## MJF/MJL Series

### differential pressure gauge design change notification

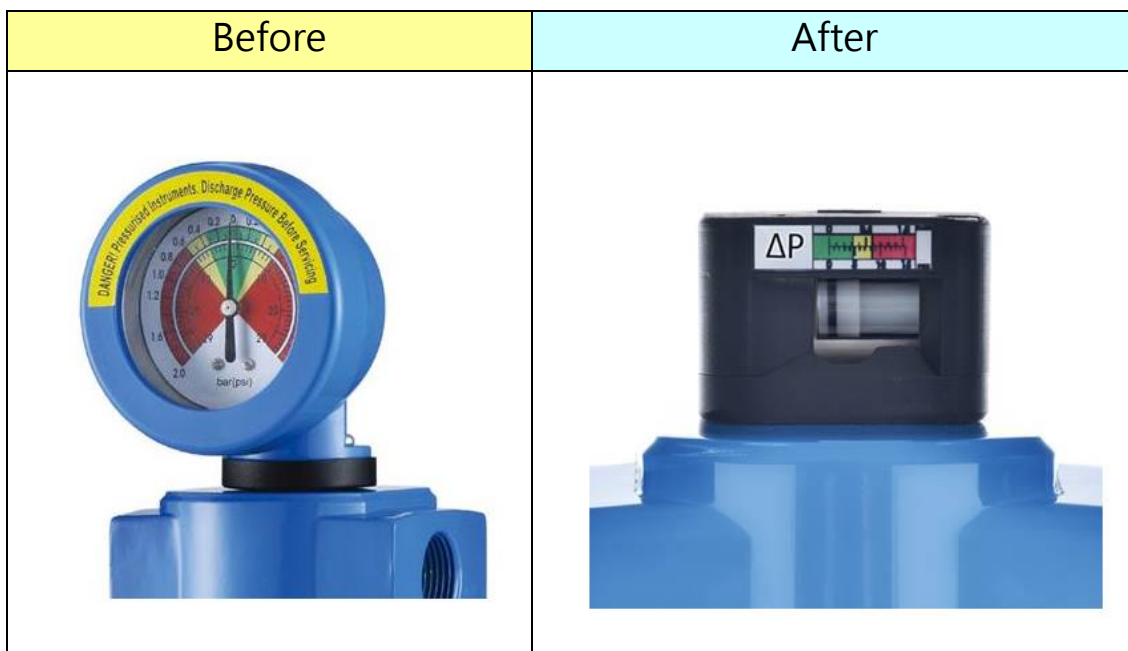
1. Model series  
MJF/MJL.
2. Design change reason  
Improve meter display stability.
3. Change descriptions
